| Office Action Summary | Application No. 10/560,074 | Applicant(s) SCHERB ET AL. | |

DETAILED ACTION

11. The prior art made of record and not relied upon is considered pertinent to applicant's disclosure in the art of "Device for Winding a Tissue Web."

(34) or a device that creates under pressure by blowing air via the Coanda effect, ¶-[0030]-[00333] and Figures 4, below:

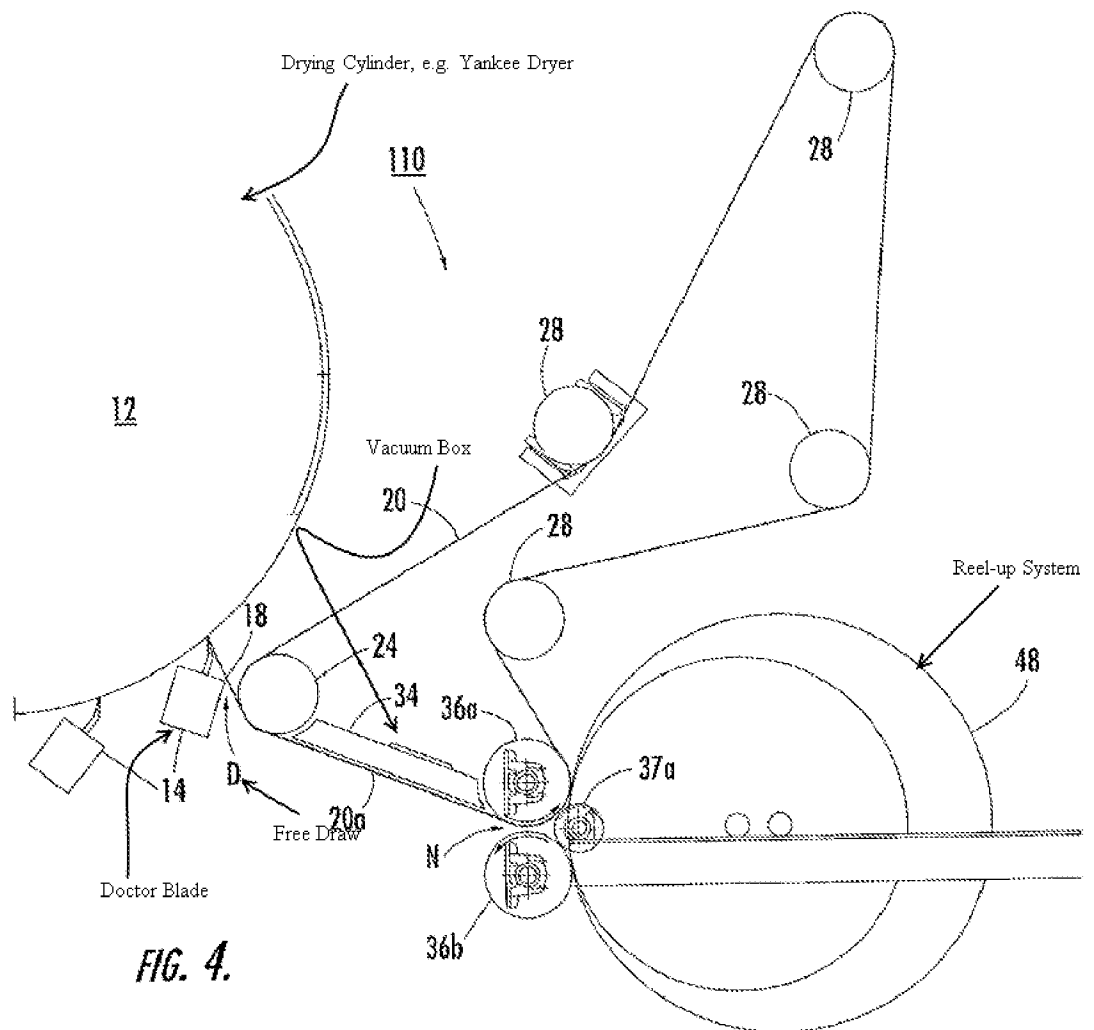
Clarke et al. teach a device for producing a tissue web which includes a drying cylinder, that could be a Yankee Dryer, a creping Doctor and winding device to reel-up the web onto a roll and a transfer device that carries the web from almost the entire run from the doctor blade to the winding roll, see figures, specially figure 4, and ¶-[0036]-[0038]. The figure show also that the web is unsupported, creating a free draw from short distance from the doctor to the beginning of the transfer device, and show that the web is supported on one side of the transfer device. Clarke teach also that the short Draw, (D) can be changed from 4 inches to 48 inches, (0.1 to 1.20 meters), which falls within the claimed range, see ¶-[0024]. Clarke et al. show also that the device can include a nip formed by a backing roll and the reel, figure 4, and ¶-[0036]-[0038]. Clarke et al. teach also that the transfer device can be a belt; preferably a permeable belt and that vacuum can be applied to the web through the permeable belt. The device can be a vacuum box

Note that Clark et al. show that the belt moves around a winding drum of the winding device, i.e., moves around the backing roll (36a) that form part of the winding device, see figure above, which is/are equivalent to the winding roll 107 of figure 1 of the current application and the web is supported in only one side on the transferring belt 20a, which

reads on the newly added limitation. As to the force at the winding nip, this is functional limitation, which implies that the system is capable and controlled to produce the claimed nip pressure and the system show by the reference, Clark et al., is inherently capable of producing such pressure at the nip, since it has all the structural limitations of the claim(s). Therefore, the reference anticipates the claims or at least the minor modification(s) to obtain the claimed invention, i.e., to apply the claimed nip pressure, would have been obvious to one of ordinary skill in the art. Note also that it is know to keep the low lineal pressure at the nip, so not to densify the web.
